STATEMENT OF ENVIRONMENTAL EFFECTS - ADDENDUM
39 Starkey Street, FORESTVILLE. DA2023/1109 for Subdivision of one lot into three and alterations and additions to the existing development

This information responds to matters raised in Council's request for information correspondence dated 5 January 2024. The submission is accompanied and supported by the following amended documents:

Figure 1 – mixed pattern of allotment sizes, orientations, and configurations within the local area

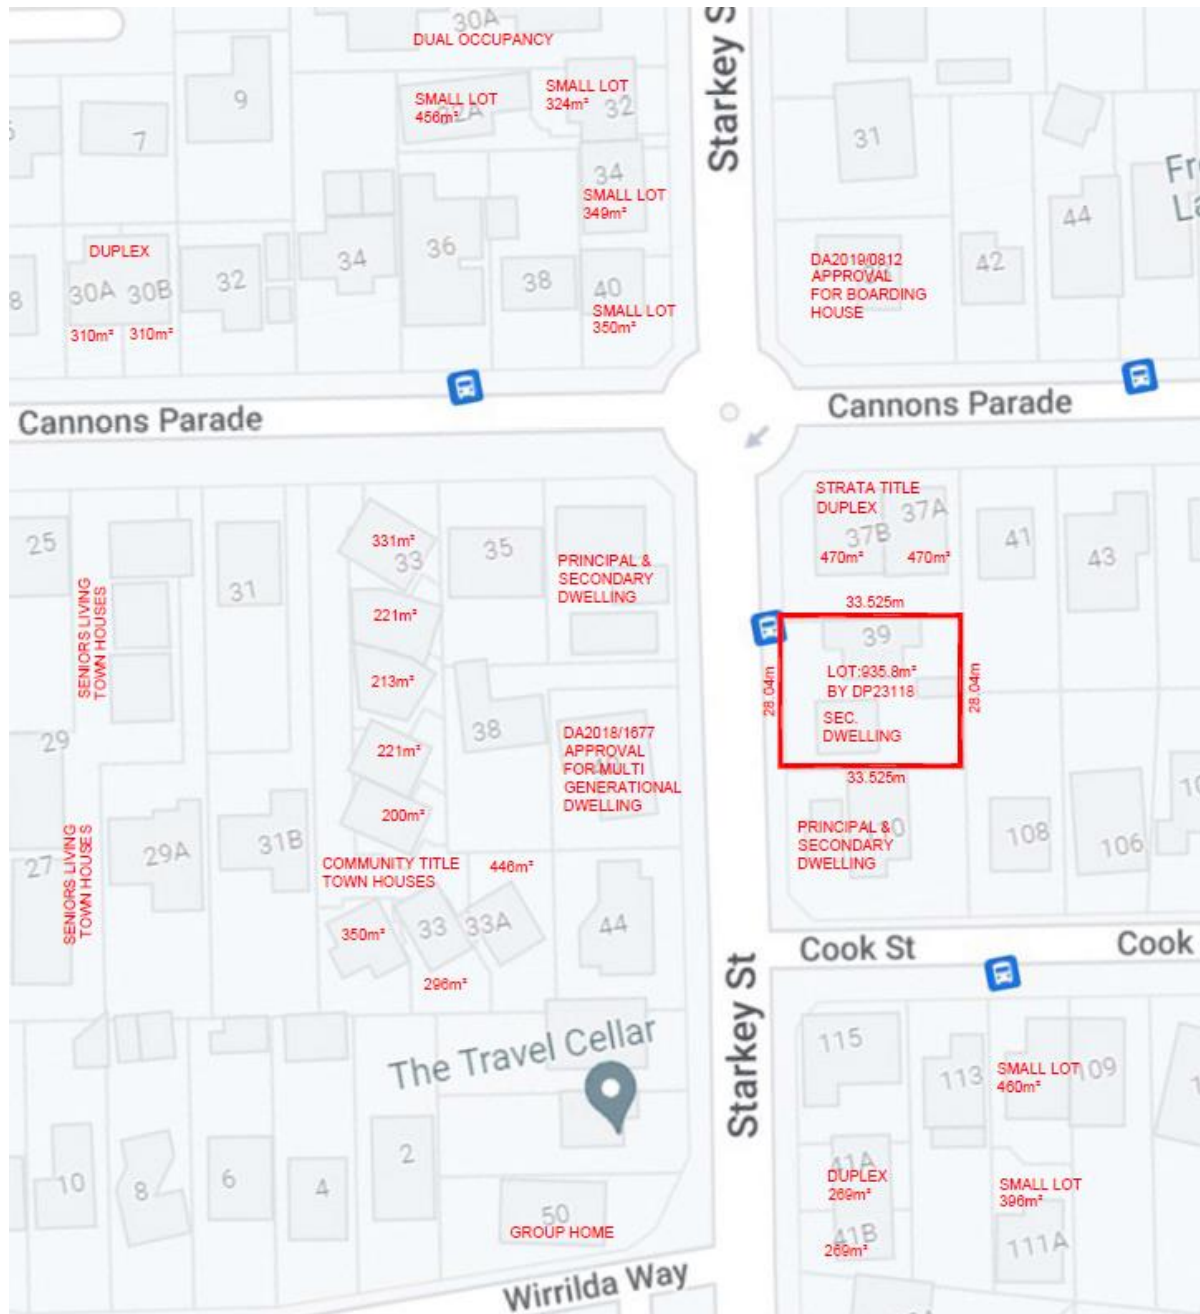
The application provides an unbalanced subdivision pattern and contains noncompliances with WDCP controls (outlined below in this letter). The newly created lots are inconsistent with the predominate pattern, size and configuration of existing lots in the locality, and are not in harmony with the established subdivision pattern consisting of predominately larger lot sizes.

It is observed that there is a mixed allotment pattern within the local area, including a mix of housing types, albeit within a low density setting. Figure 1 depicts features of the local allotment and housing pattern.

Taking guidance from the planning principle for 'compatibility of a proposal with surrounding development', established in *Project Venture Developments Pty Ltd v Pittwater Council* [2005] NSWLEC 191 at 22-31, a proposed development does not need to be the same in order to be in harmony / compatible. There is a mixed allotment pattern and the existing and proposed lots are compatible with this mixed character.

The proportions of the proposed allotments are more consistent with the predominant pattern (rectangular shape, proportions, area) within the local area than the existing lot.

Figure 4 – proposed landscape plan

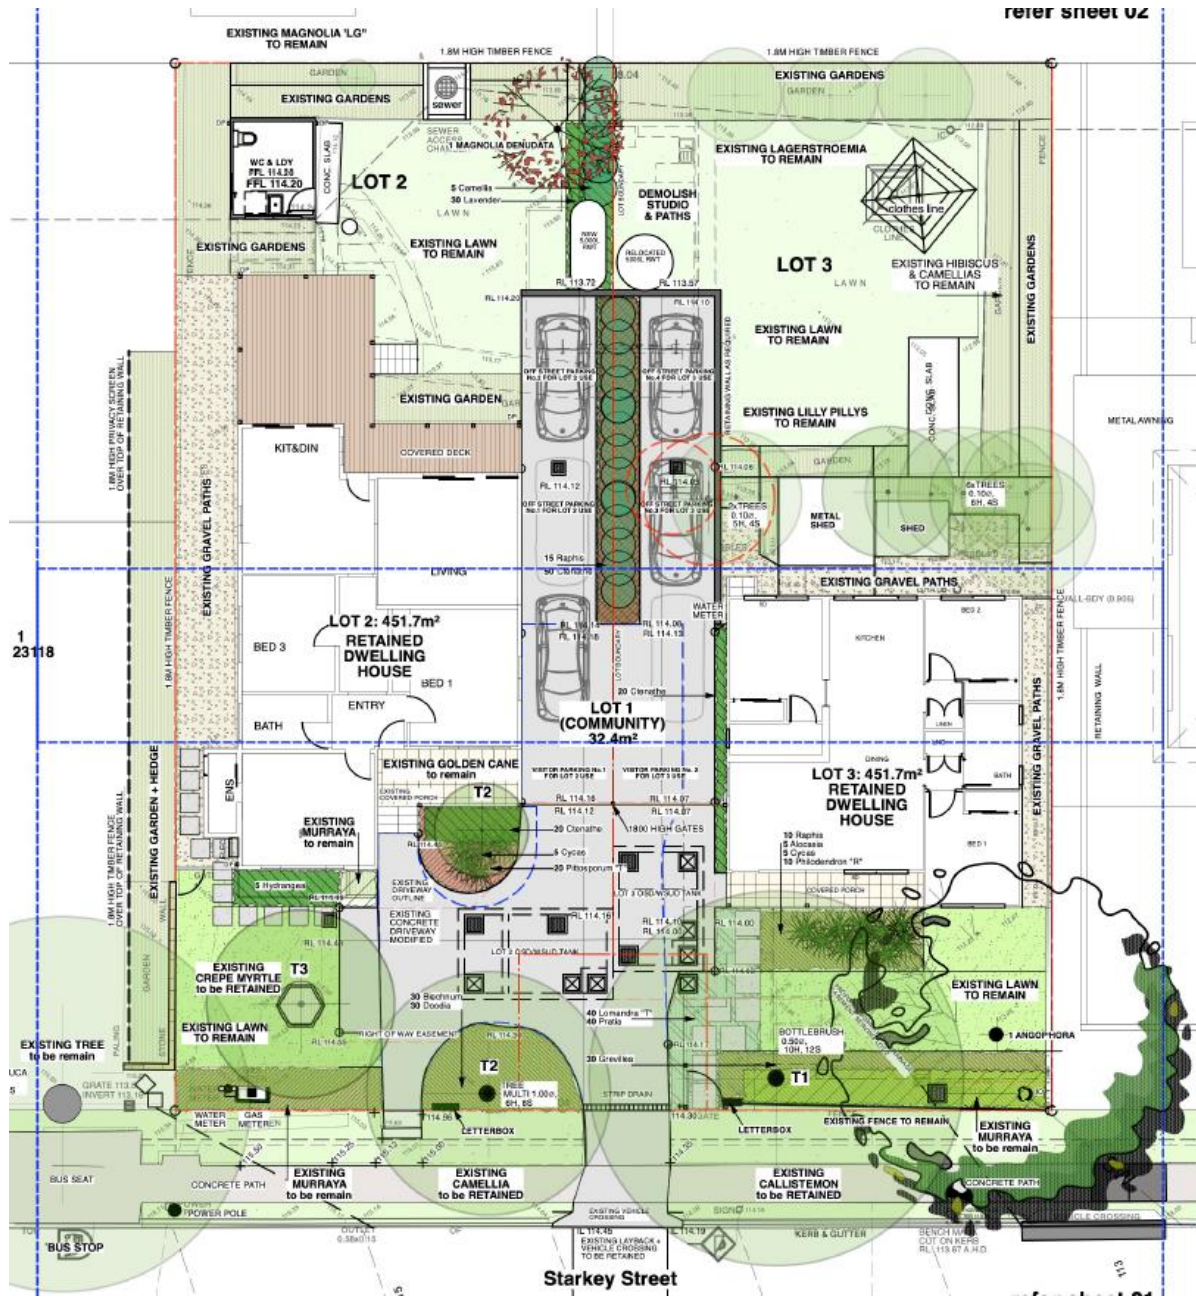
The proposed development layout within the frontage includes extensive hardstand areas that if approved does not allow adequate areas for replacement tree planting to provide the necessary landscape outcome to satisfy WDCP control D1 Landscaped Open Space and Bushland Setting, where the requirements are to: enable planting to maintain and enhance the streetscape; and provide for landscaped open space with high shrubs and canopy trees of a size and density to mitigate the height, bulk and scale of the building.

It is Landscape Referral's assessment that the proposed layout impacts upon the viability for retention of existing trees of amenity value and worthy of retention, and amendments should be attended to providing a design layout solution that is able to satisfy the requirements of the WDCP, including:

- *realignment of turning area away from T1 Bottlebrush and reduction of widened driveway (refer Figure 1 below),*
- *retention of existing hardstand around T2 Sasanqua and reduction of widened driveway (refer Figure 2 below).*

The submission is accompanied by an amended landscape plan which addresses the issues raised above, including retention of the trees identified and a suitable range of replacement plant species to maintain and enhance the property's landscape setting.
